| LINE  | QUANTITY | UOP | CAT. NO. | ITEM NUMBER | UNIT PRICE | AMOUNT |
|---|----------|-----|----------|-------------|------------|--------|
| ***** ADDENDUM NO. 6 *****  |          |     |          |             |            |        |

Addendum No. 6  
Berkeley Springs Bath House  
DNR 209090

**DEPT. of Natural Resources**  
**Additions and Alterations to**  
**Berkeley Springs Bath House**

**DNR-209090**

| REV. BY:<br>RJK                              | DWG. DESCRIPTION:<br>ADDITIONAL WALL AND DOOR<br>DEMOLITION | DWG. NO:<br>AD-003 1 OF 5 |

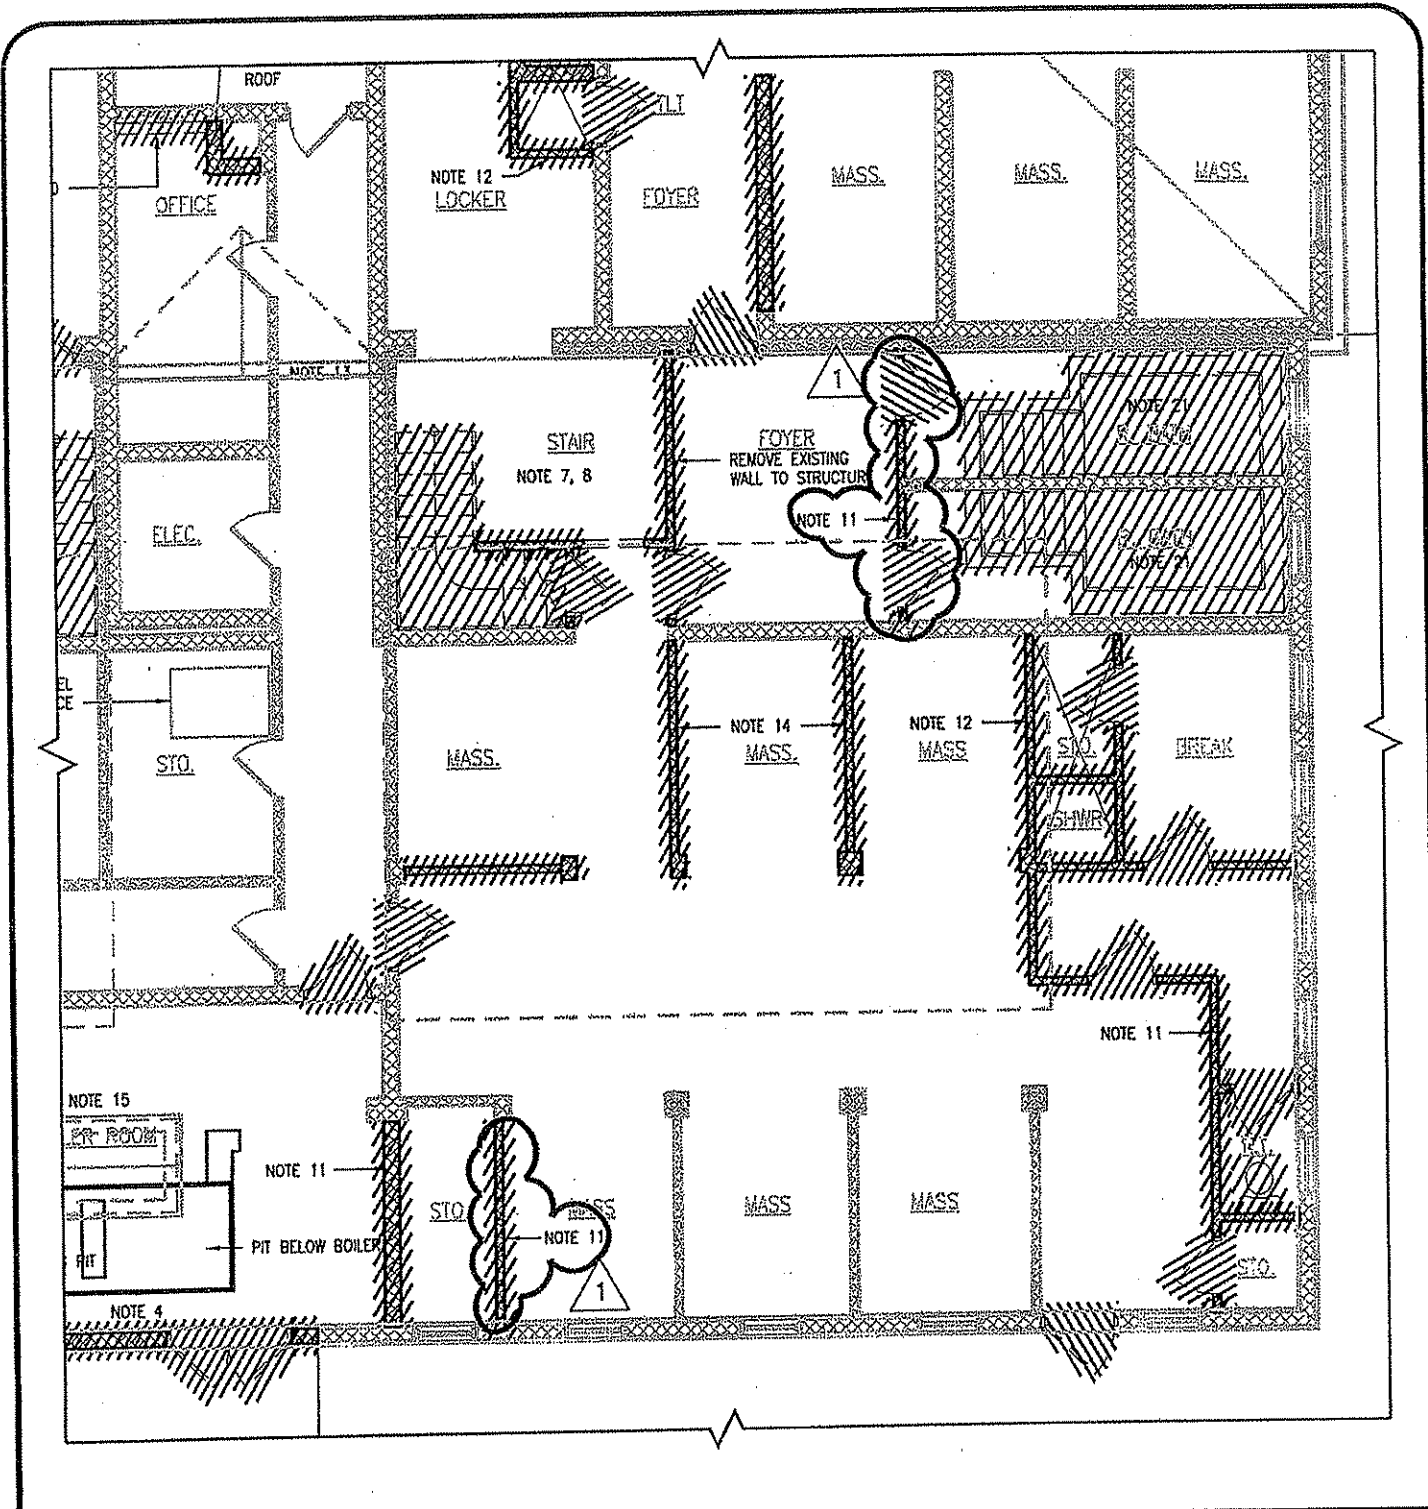
- 3.01 Sheet A-0.2 Demolition, Sheet A-1.1-Floor Plan, Sheet A-6.1 Door Schedule  
MODIFY: According to sketches that are "Clouded" on attached AD-003; 5 pages.  
Removal of certain walls and widening of doors will provide better access into space with one piece fiberglass tubs as replacement Roman Baths.

| REV. BY:<br>RJK                              | DWG. DESCRIPTION:<br>ADDITIONAL WALL AND DOOR<br>DEMOLITION | DWG. NO:<br>AD-003 3 OF 5 |

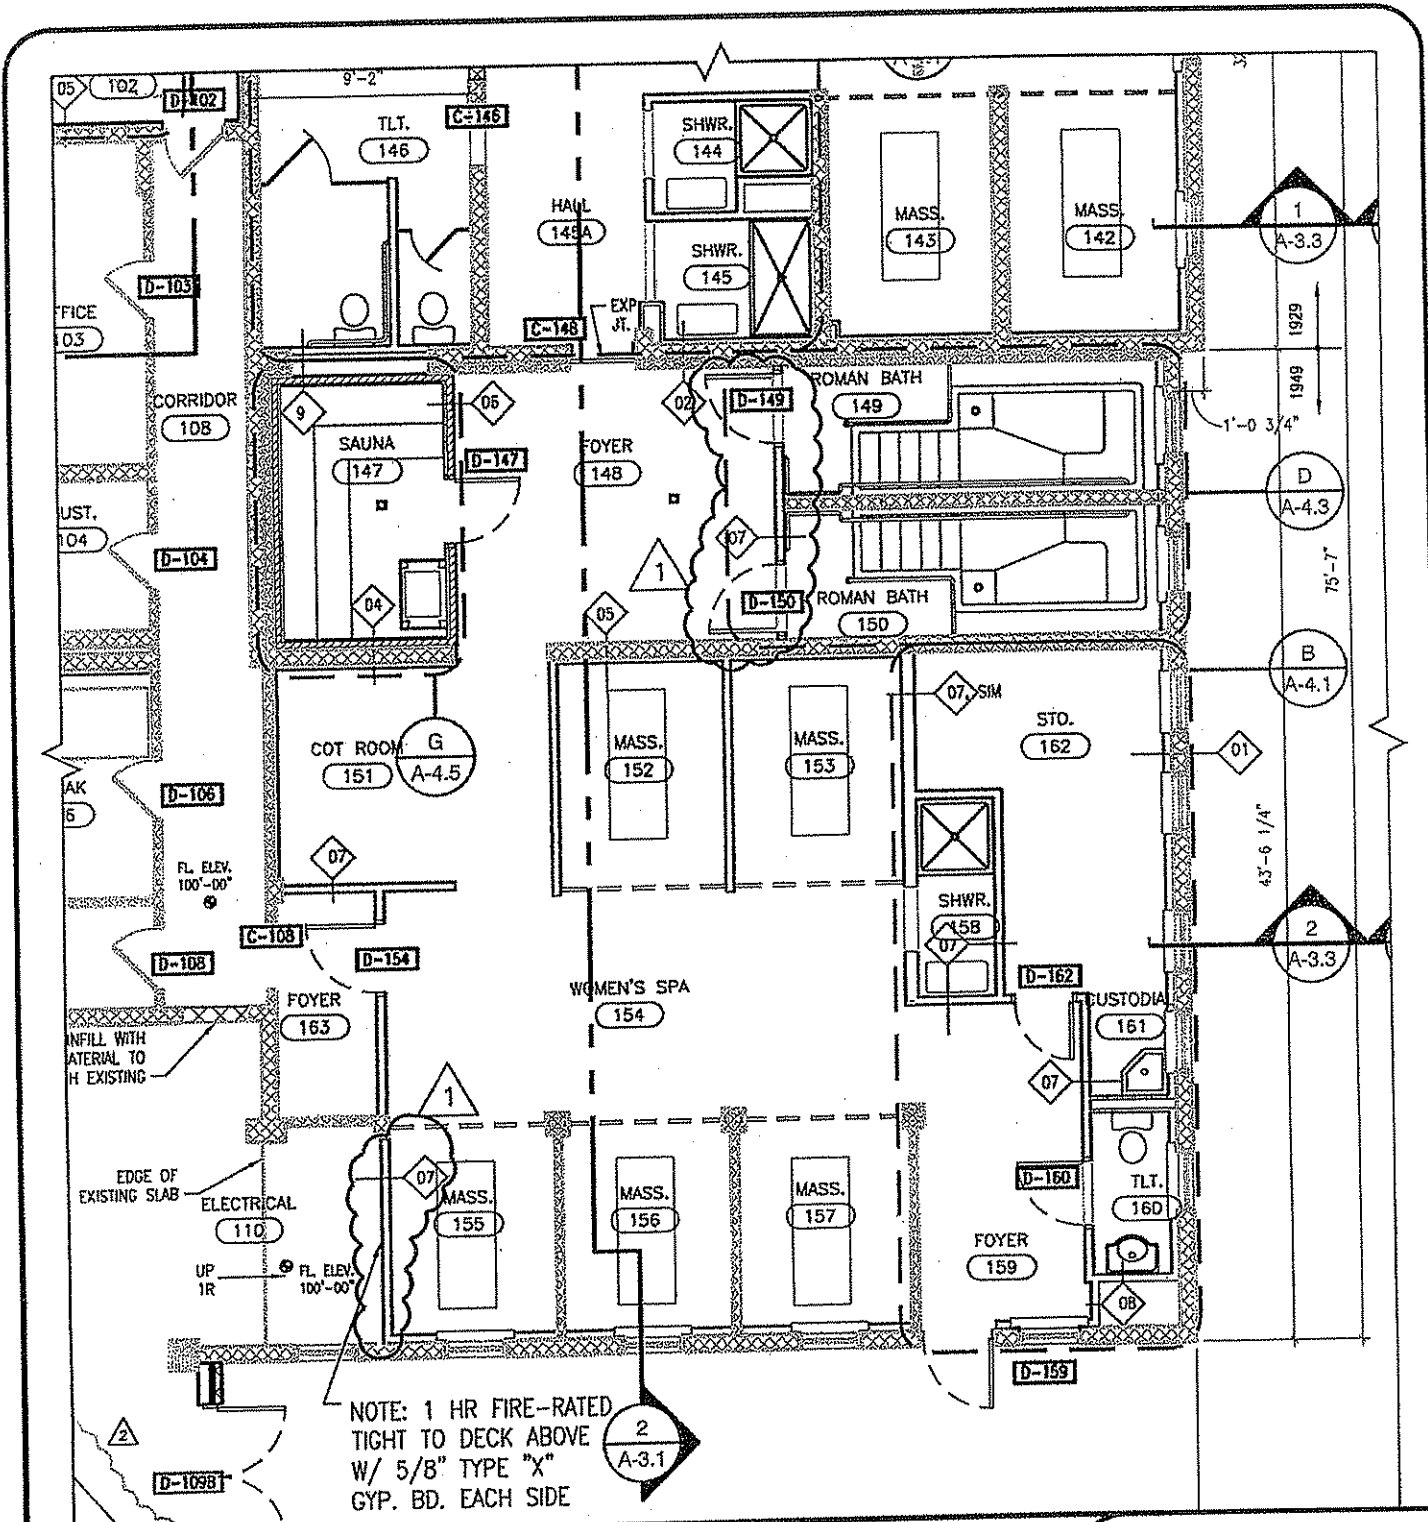
- 4.07 Q: How are we to get the new fiberglass roman baths into the building?  
A: See section 3.01 above and AD-003. Additional walls and/or doors have been modified to accommodate new baths. However, the general contractor should plan on installing the roman baths, early in the project, so that walls can be erected in a timely fashion.

| DATE:<br>02-19-09                            |   | SHEET REF:<br>A-2.2       |

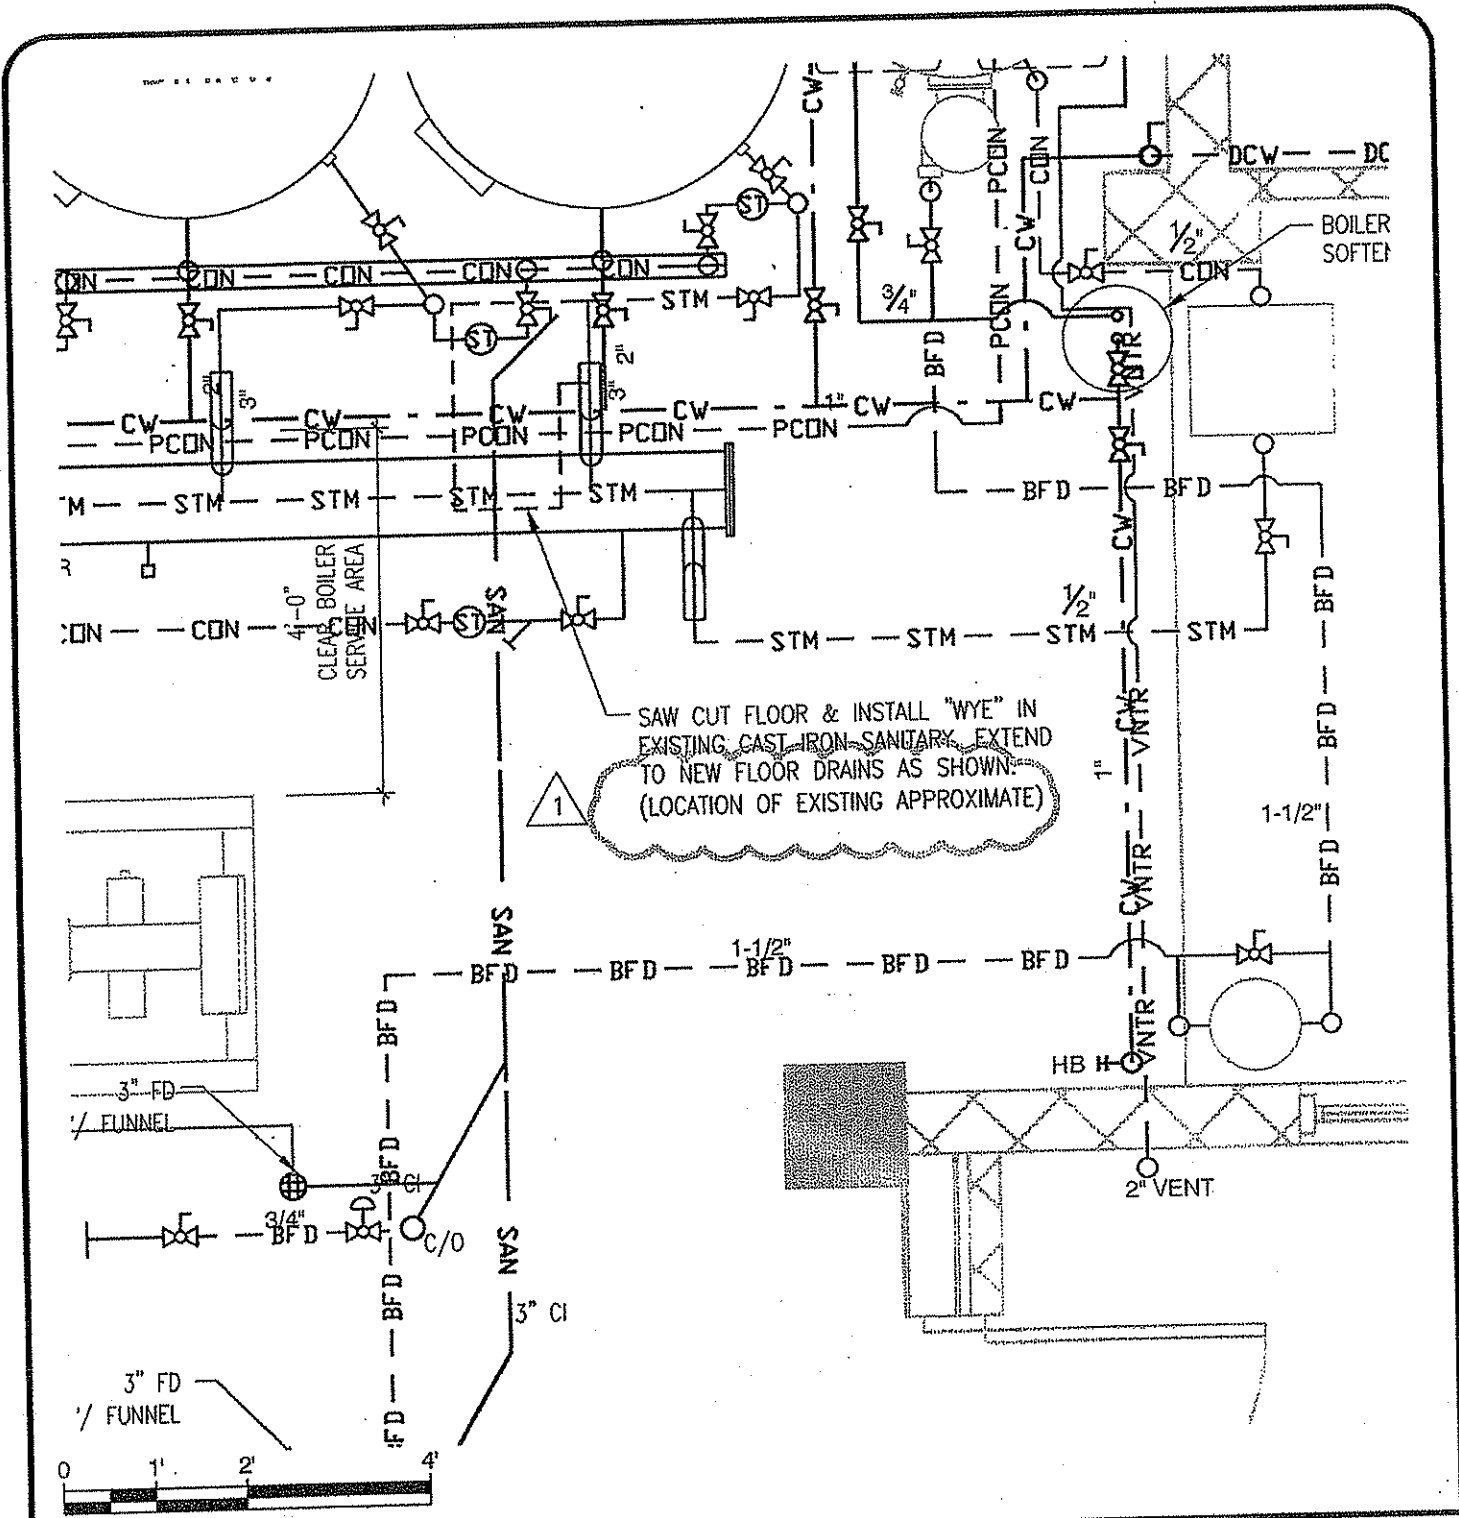
- 3.04 Sheet A-2.2- Front elevation façade.  
ADD: New 24" x 24" access to crawlspace with permanent screened louver, see AD-004 attached.
- 3.05 Sheet A-4.6- Enlarged Reception Desk Details  
CLARIFY: See AD-010 attached.

| DATE:<br>02-25-2009 |                                      | SHEET REF:<br>P-4.1       |

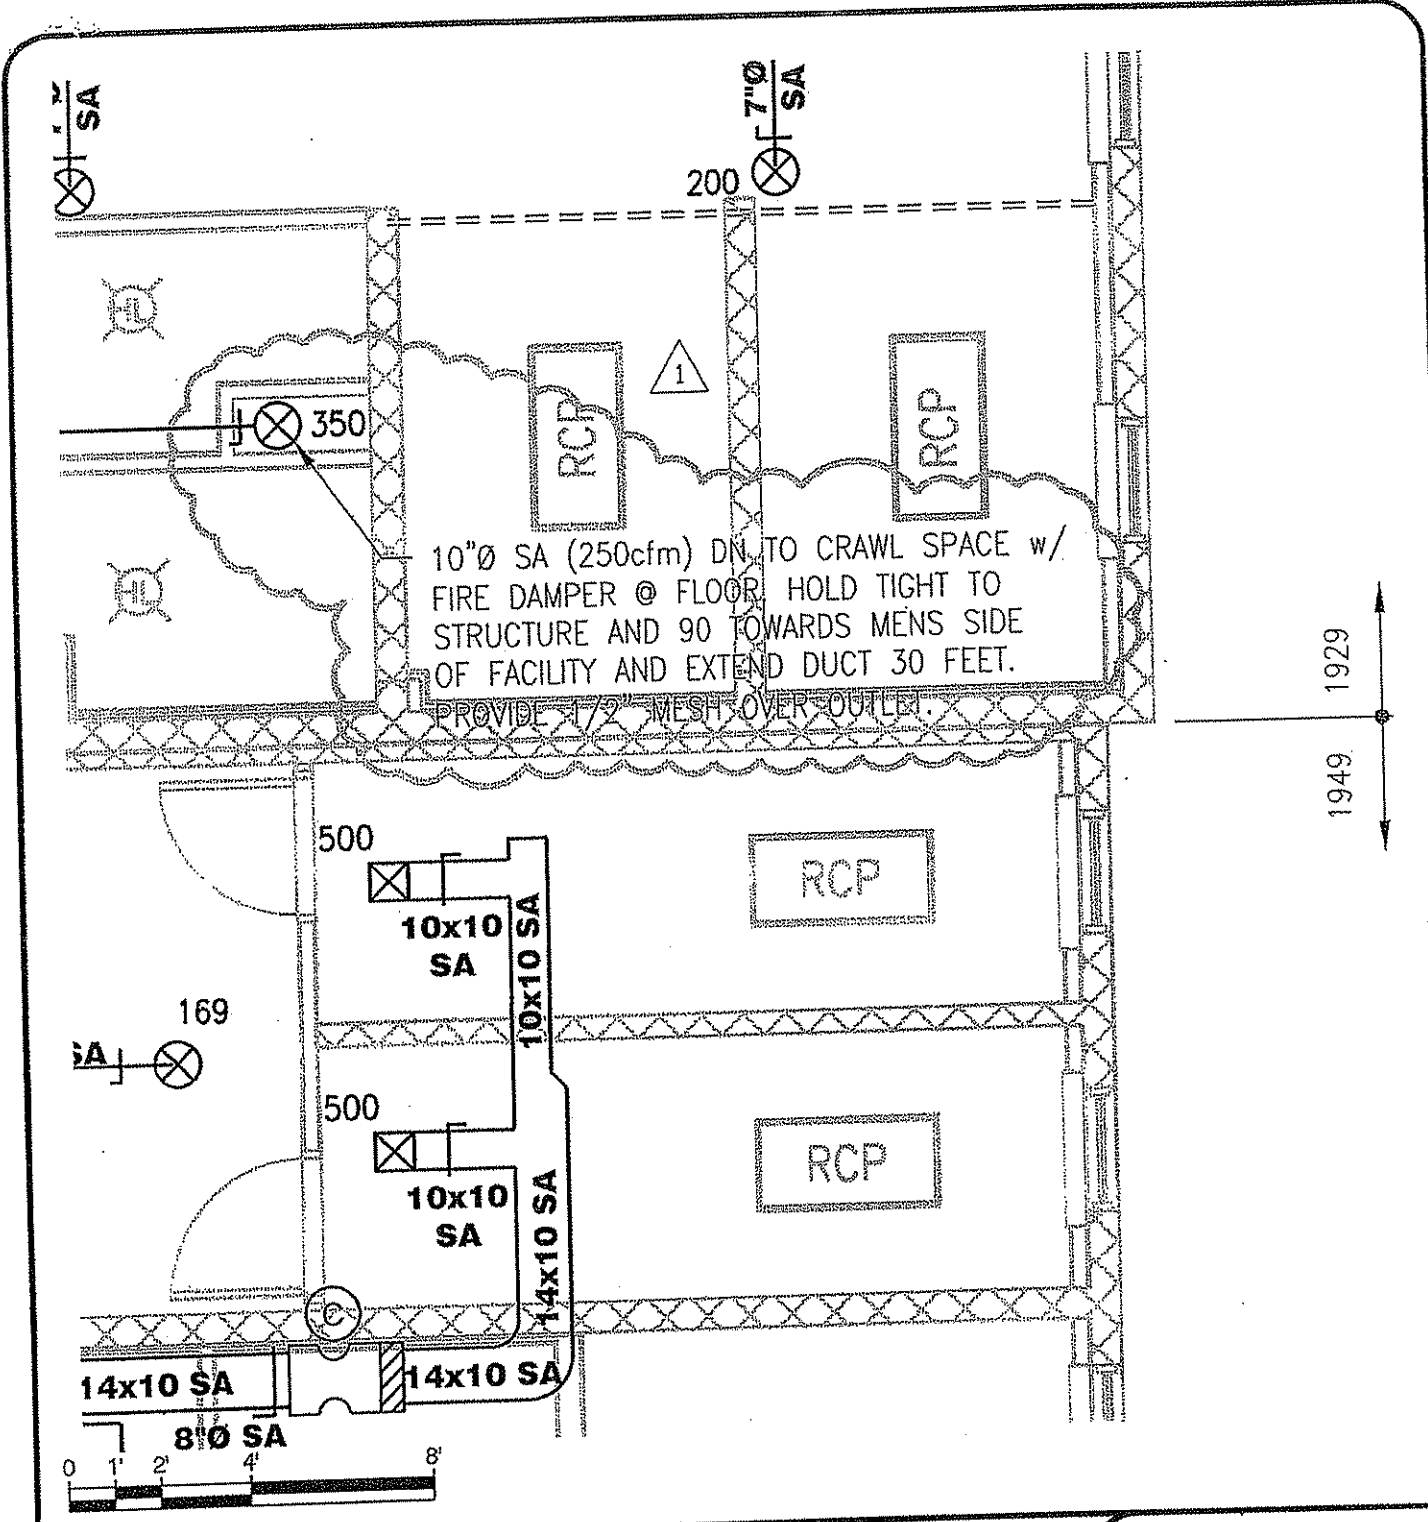
- 3.08 Sheet P.4.1  
ADD: Note: " Extend (Sanitary)to new floor drains as shown. (Location of existing approximate)" See attached AD-005.

| DATE:<br>02-25-2009  |                                       | SHEET REF:<br>M-1.1        |

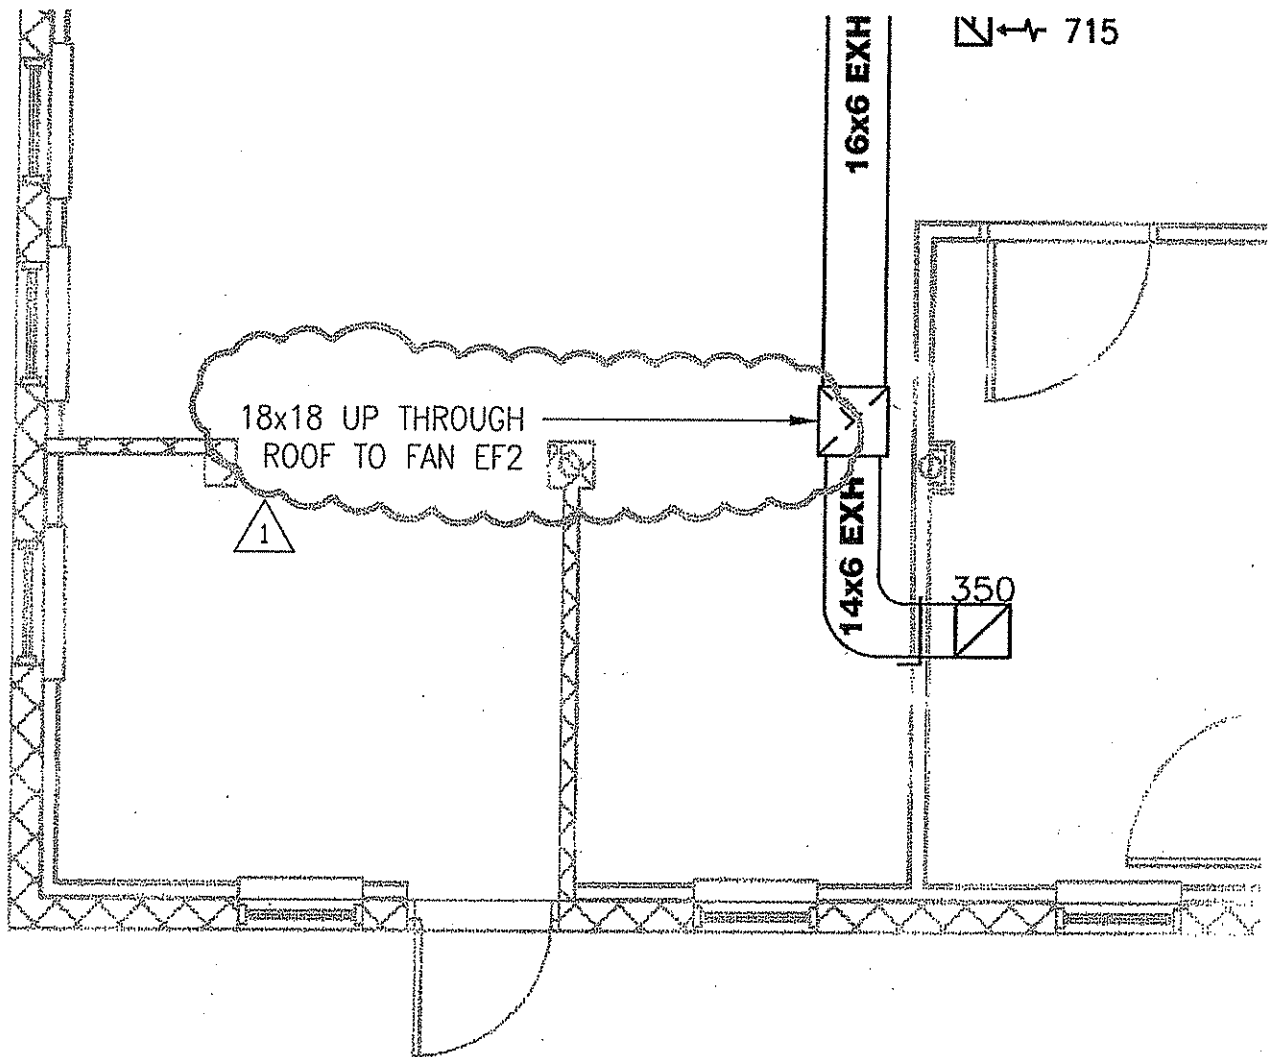
- 3.09 Sheet P-5.1, Plumbing Details  
ADD: Vaporizer System Detail, See AD-011 attached.
- 3.10 Sheets: M-1.1  
ADD: Note: See clouded area of AD-006, 1 of 14 attached.  
ADD the following as Note #19: "Final coordination of scope of work, dimensions, fixture placement, routings, etc is the responsibility of the GC and all sub contractors prior to bidding. Verify all field conditions and measurements prior to bidding. Coordinate all work with other trades. Coordinate all mounted devices with all other trades prior to installation. Firestop all penetrations of fire walls (see arch plans) and floors."
